Burlington Development Review Board

Development Review Board

Wednesday, March 11, 2026, 5:00 PM

To: Development Review Board
From: Mary O'Neil, AICP, Principal Planner
Date: March 11, 2026
RE: 633 Main Street; ZP-26-50

Drawing No.
C-1.1

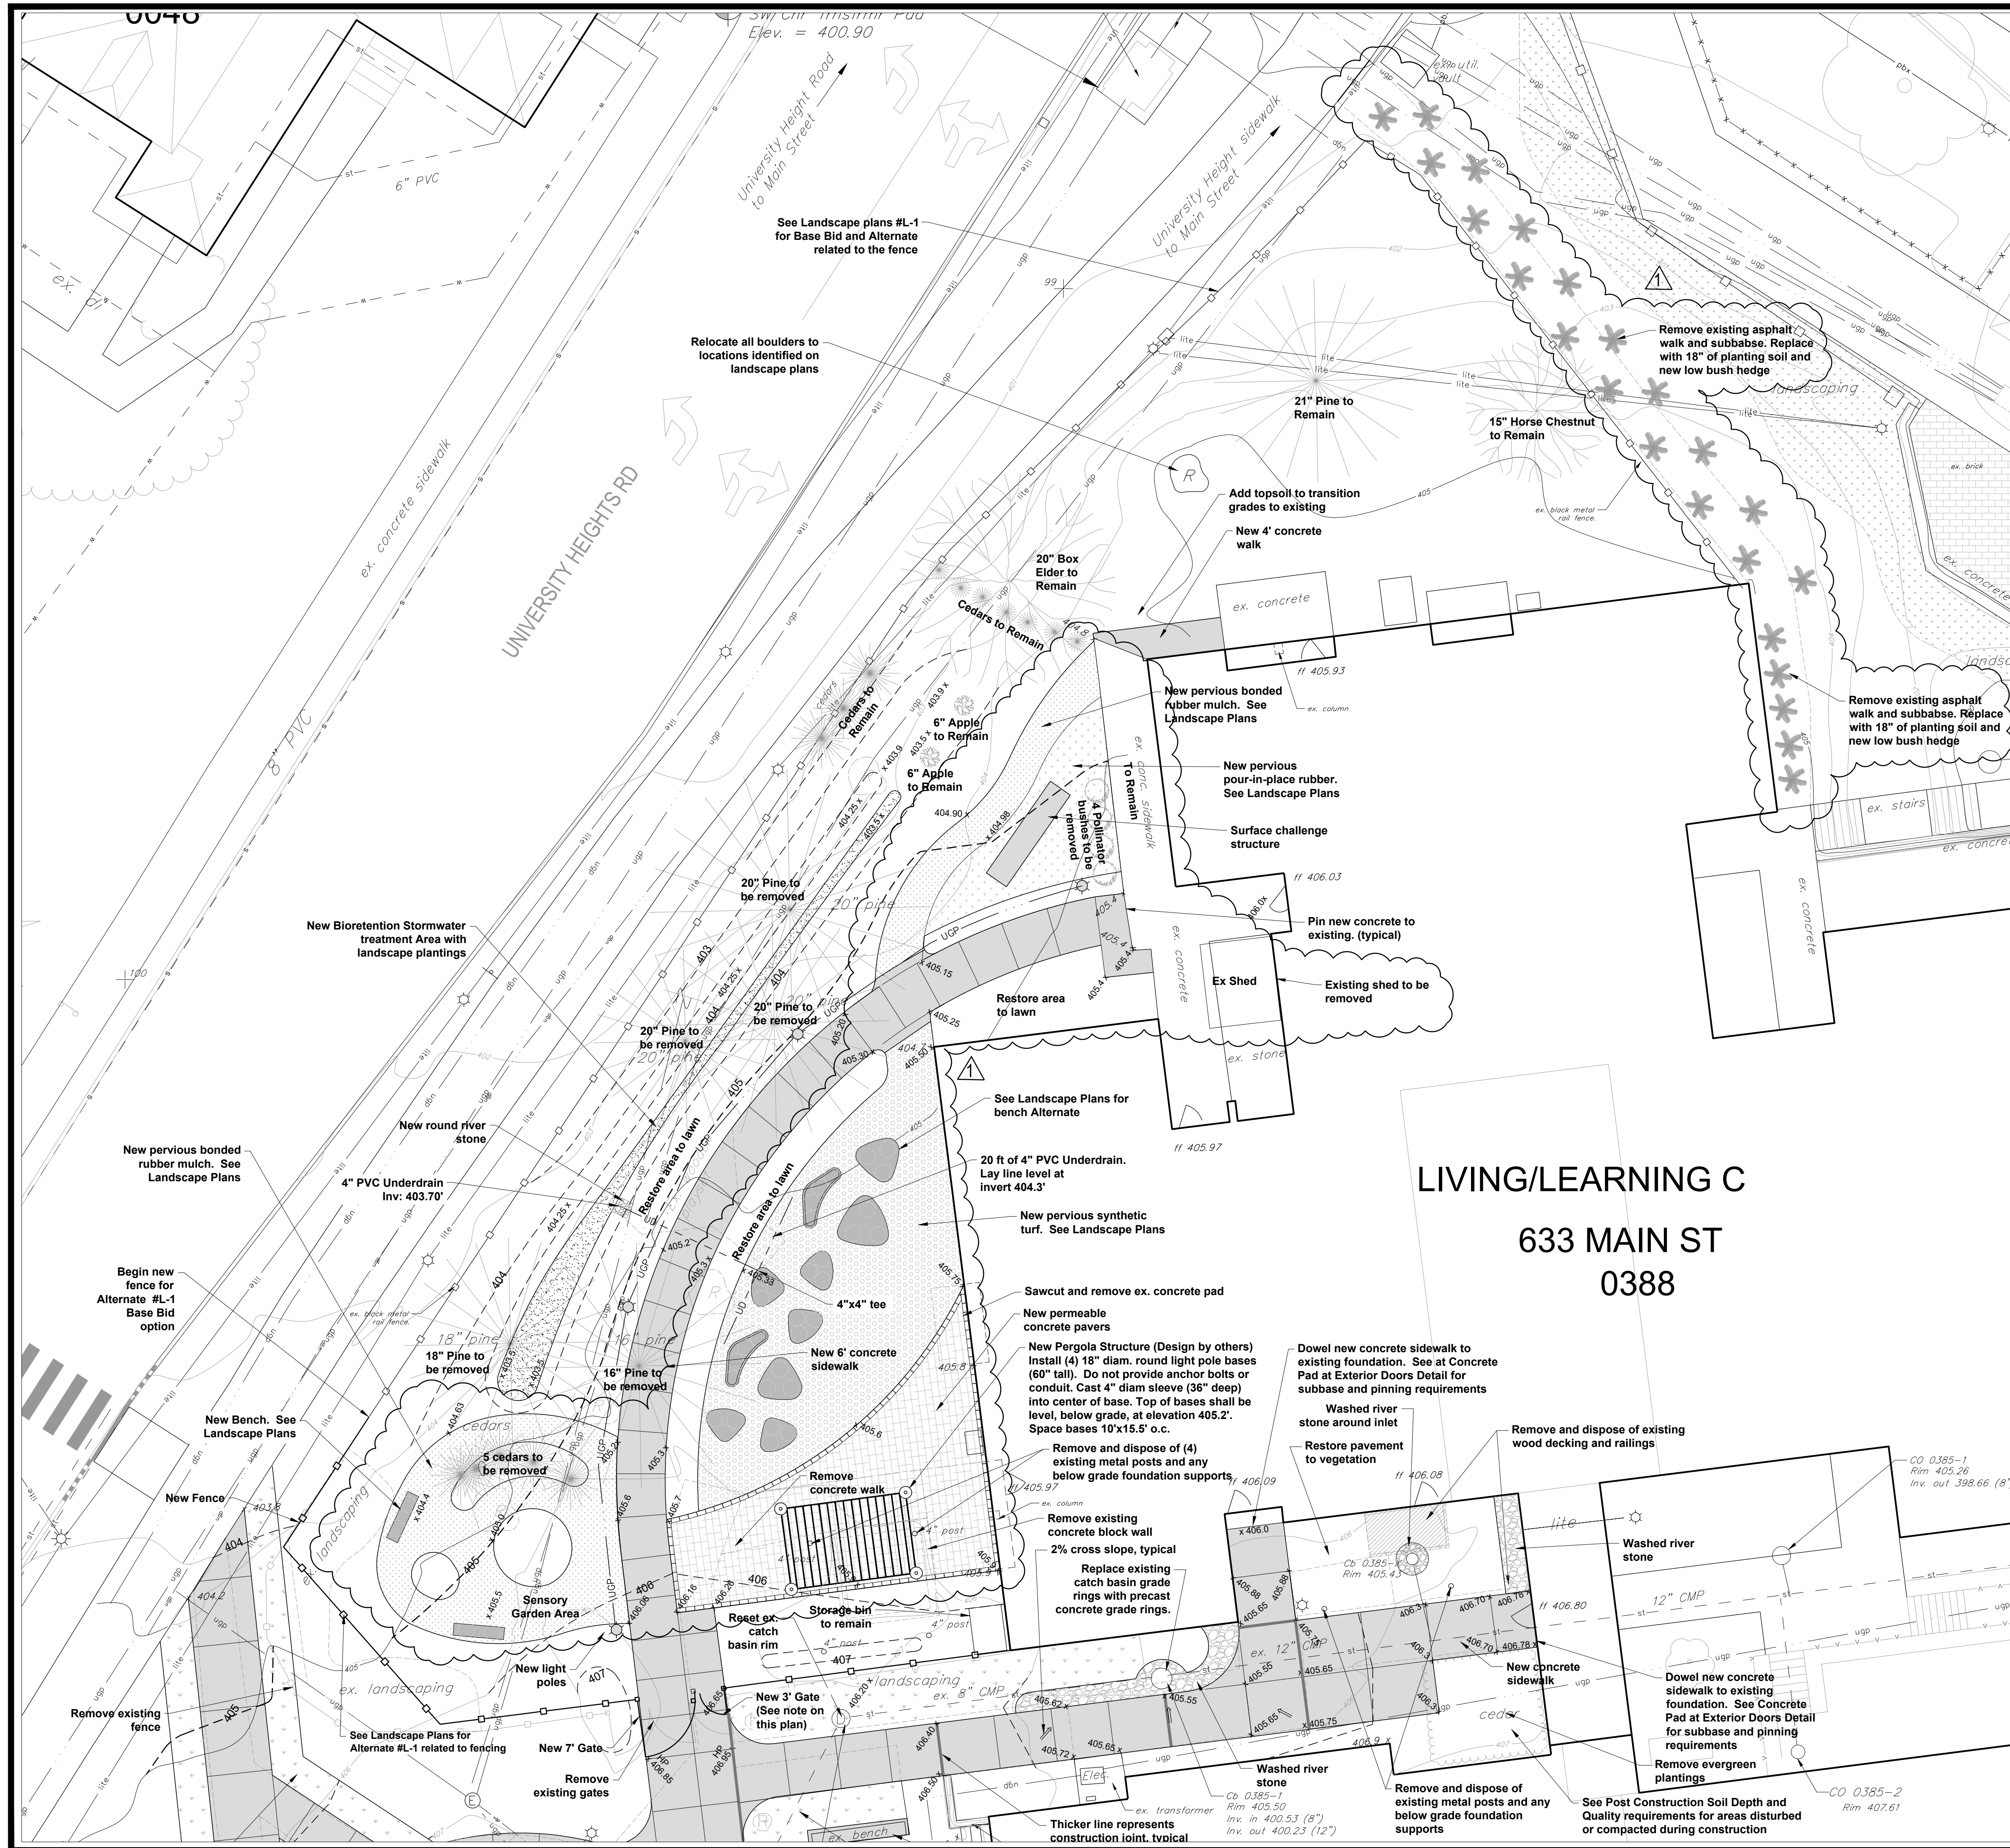
- Formalization of benches and other site furnishings. [Sheets C-1.1, L1.0, and L4.1]
- Removal of the asphalt walk at the north end of the site and replacement with a low bush hedge. [Sheet C-1.1]

- Removal of an existing shed and replacement in-kind of existing concrete surrounding the shed area. [Sheet C-1.1]
- Addition of a pergola with two tables to enhance shaded seating opportunities. [Sheets C-1.1, L4.1, and L4.2]

Drawing No.
C-1.3

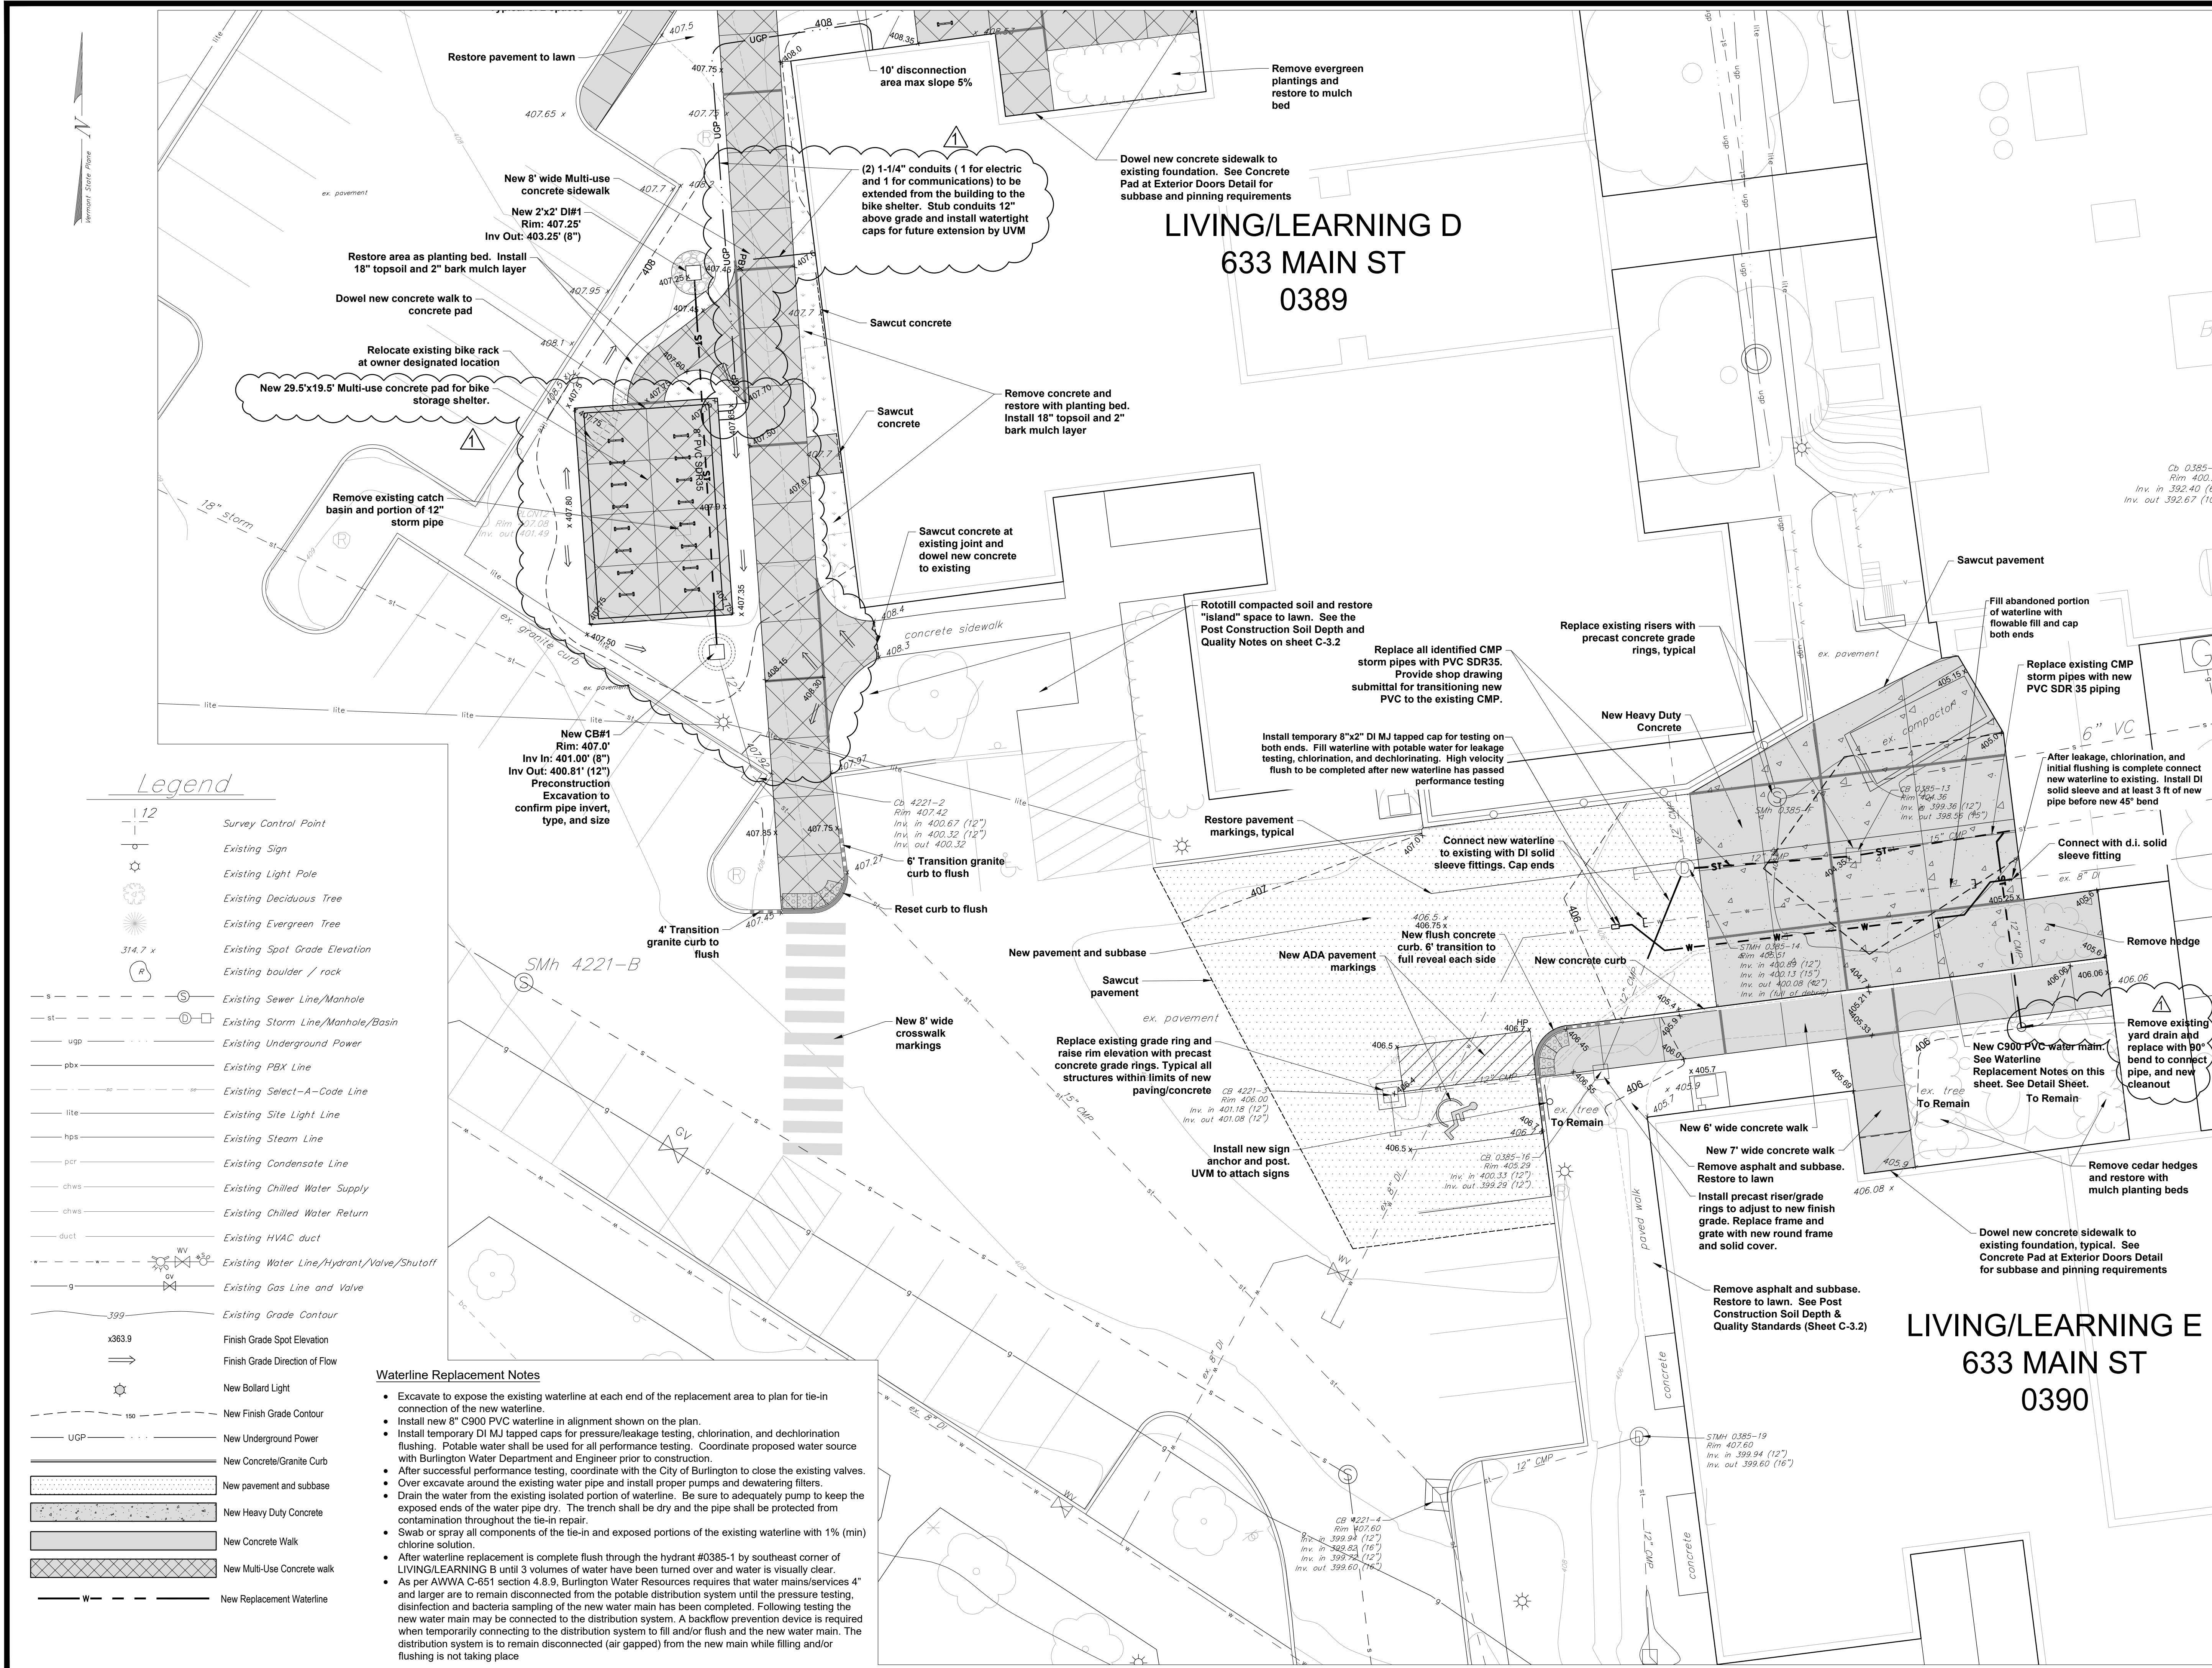
- Increase in the concrete pad for the bike storage shelter from 28' x 17' to 29.5' x 19.5'. The shelter is going to be 6" longer to be 27.5' overall roof footprint [Sheet C-1.3]
